PCN #: E62x1-K515-Revision_DC-PCN-20260128

Change Title: EMDCx Mechanical Design Update

Date of Publication: 28 January, 2026

Illustrations of change

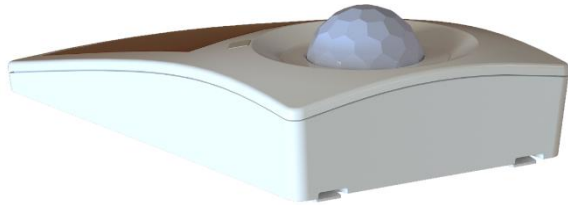
- Removal slots

- Support for lens covers (3 lens covers and 1 slot cover ring included)

- Battery cover

- Customer feedback indicated that easier removal of the product from the wall or ceiling-mounted backplate would be beneficial. The new design provides two removal slots that can be used to push EMDC off the backplate.

- For certain applications, it is desirable to limit the detection field of EMDC by means of lens covers. The new design provides a set of 3 dedicated lens covers which can be attached to dedicated mounting slots to address common use cases and modifies the housing to enable easy attachment. One ring-shaped slot cover assembled onto the attachment slots so that those are not exposed in cases where no lens cover is used.

- To further enhance product safety, the new design will add a dedicated battery cover with screw attachment that prevents extraction or ejection of the battery.
